SAKURA EAST PRO JZ23-41

SAKURA EAST PRO JZ23-41 WITH REZONING 18.743

PLAN REVIEW CENTER REPORT
Planning Review
November 8, 2023
JZ23-41/JSP23-09 Sakura East PRO

sheet title:
Tree Preservation Plan

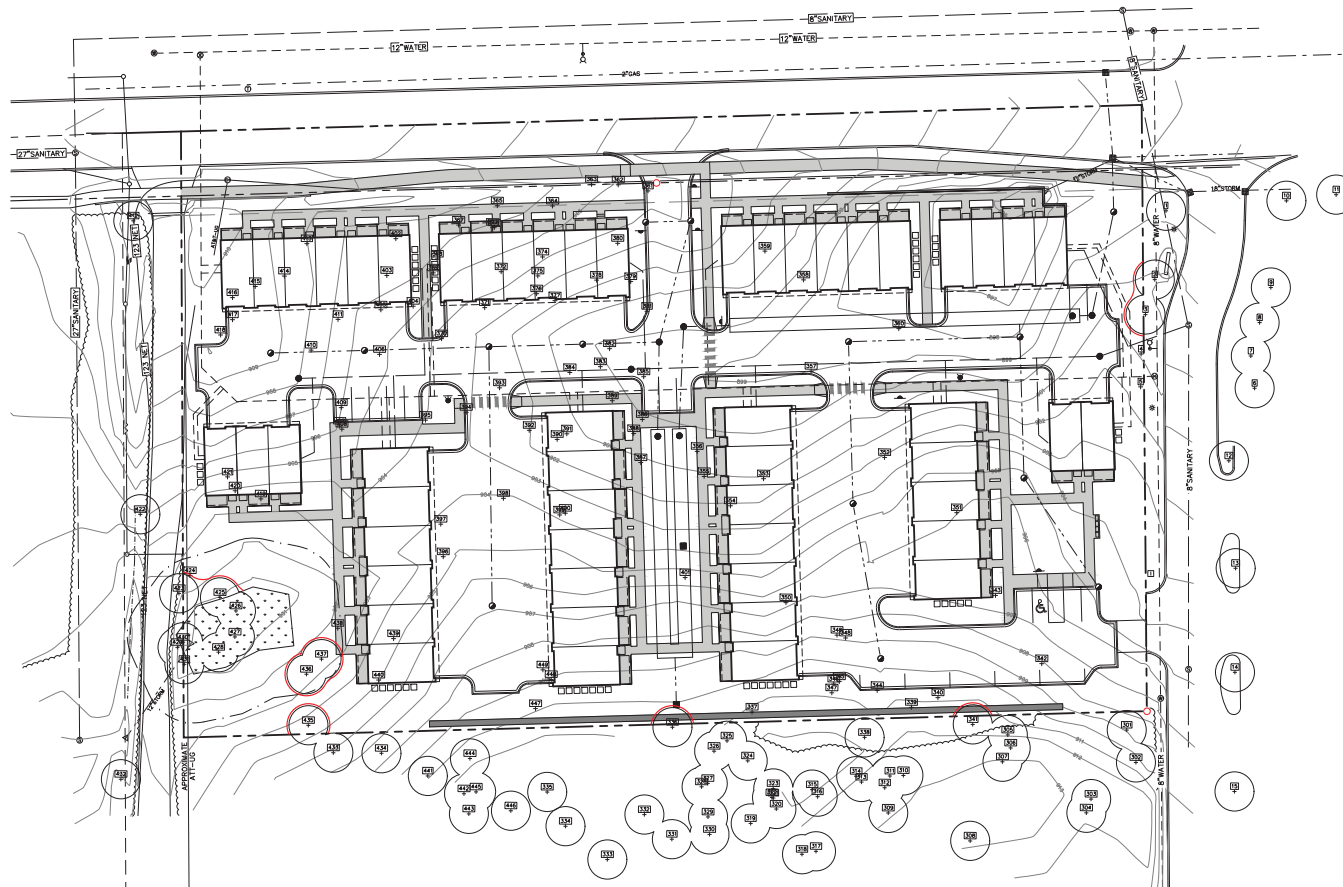
The Plan and Report depict one wetland onsite that is 0.03 acres. MSG visited the Site on November 6, 2023 to evaluate the wetland limit lines depicted on the Sheet L-3 of the Plan. The observed conditions at the project site generally consisted of vacant, mostly wooded land. Wetland delineation markers (labeled pink ribbon) were observed that generally corresponded to the perimeter of Wetland 1. Wetland 1 was observed to be forested wetland. **MSG does not agree with the delineation of Wetlands 1 as depicted on the Plan and flagged in the field. Based on MSG's assessment of Site conditions, the boundaries of Wetland 1 should be extended up to the off-Site access road and include trees 423, 424, 436, and 437.**

Figure 1: Current Zoning

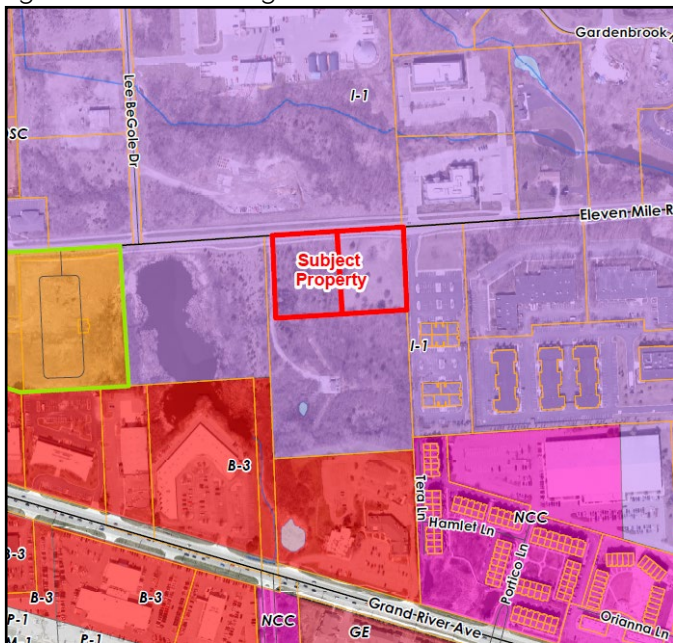
To the **east** is an area zoned I-1 Light Industrial. There is an office complex there with two existing buildings, with a third building approved to be constructed. There is no firm timeline on when that building would be constructed. This area is planned to remain Light Industrial use in the City's Master Plan. If residential uses are located adjacent to the property, the uses permitted in the I-1 district would be severely restricted compared to the list of uses that could otherwise be permitted. In addition, there is no berm separating the properties, as is required when non-residential uses are adjacent to residential uses. It would be the applicant's responsibility to provide the required berm and screening on the parcel to be developed with residential uses. No such berm is currently proposed

The proposed residential use would be surrounded on all sides by industrially zoned properties. There is no obvious connection to the larger Sakura Novi development, except for the sidewalk along 11 Mile Road and identical townhouse product type to be developed. The lack of contiguity between the projects is a significant barrier to justifying the proposed rezoning. Another barrier could be the completion of the planned road extension of Lee BeGole Drive down to Grand River, which preliminary designs have shown to be located just west of the subject property. In addition,

Figure 2: Future Land Use

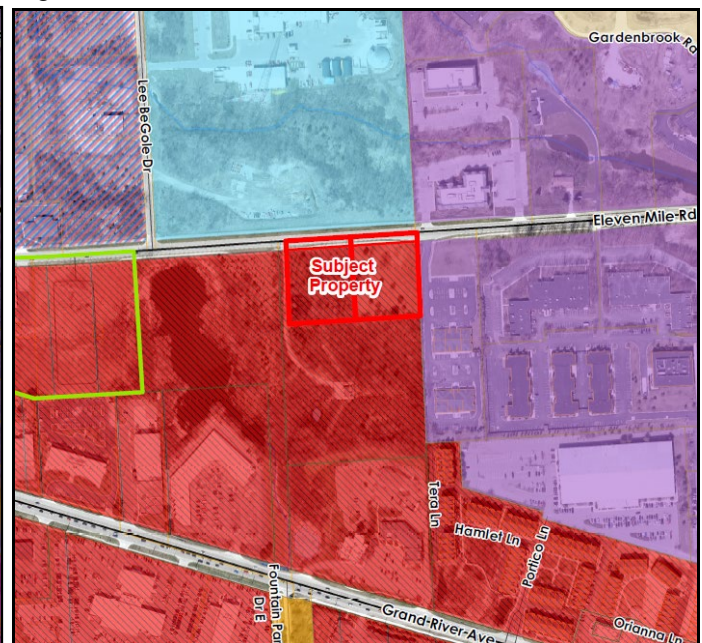
4. Future Land Use: The City's Future Land Use map indicates Town Center Gateway for this site, which corresponds to the Gateway East district. The GE district allows multifamily residential under a Special Development Option process. However, the SDO requires a minimum acreage of 5 acres, and there are many other conditions for approval in order to ensure compatibility between adjacent areas. **The applicant's requested zoning category, TC-1, is not consistent with the Master Plans' recommendation. The density recommended on the Future Land Use Map for this area is 13.6 dwellings per acre, while the applicant is proposing 16.6 du/ac.**

Adjacent to Public Rights-of-Way – Berm/Wall, Buffer and Street Trees (Zoning Sec. 5.5.3.B.ii, iii)

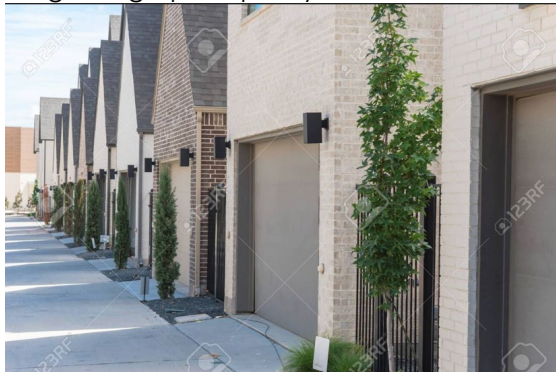
1. The project does not require any berm along 11 Mile Road and one isn't proposed.
2. **The calculations need to be revised per the TC-1 requirements, and the correct number of either Canopy/Large evergreen trees OR subcanopy trees must be provided.**

Photo 1: View of buckthorn scrub/shrub understory, facing east.

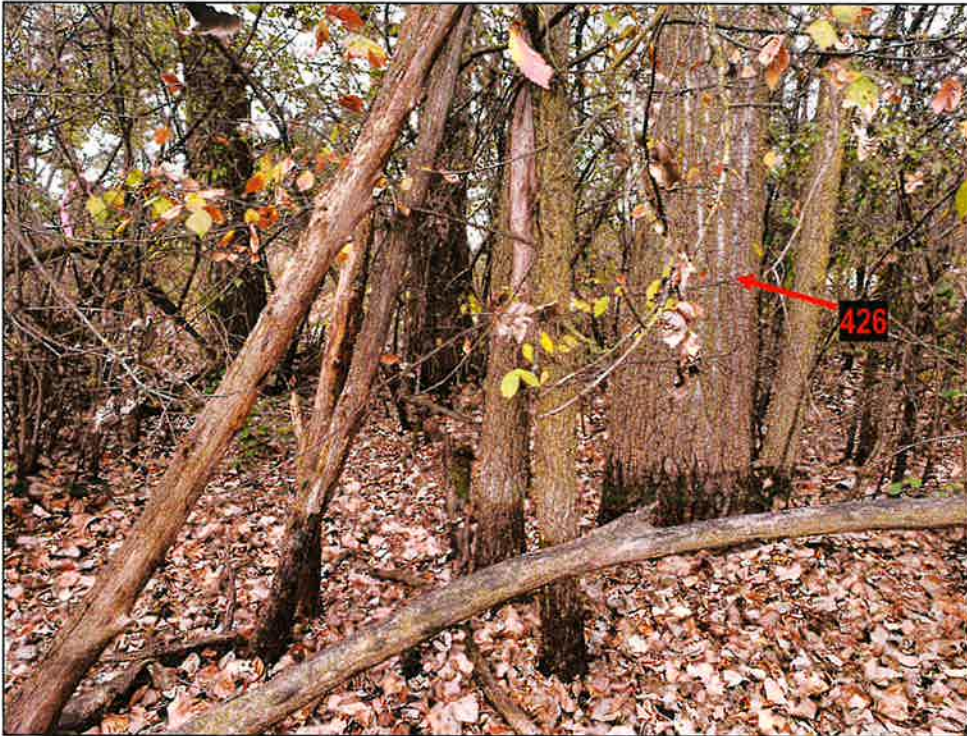
The City of Novi Regulated Woodland Map indicates the property does not include a City-regulated woodland (Figure 1). Based on MSG's review of the arborist survey performed by Land Design Studio (Plan Sheets: L-3 "Tree Preservation Plan" and L-4 "Tree Survey") and a site visit performed by a MSG on November 6, 2023, MSG has determined this site should not be considered a City-regulated woodland. The parcel is mostly wooded; however, it is a very low quality forest. The site is almost completely dominated by buckthorn, a highly invasive tree species, with only a few quality trees interspersed at a low density, including sugar maple, crab apple, and little leaf linden. Site photos are included in this letter.
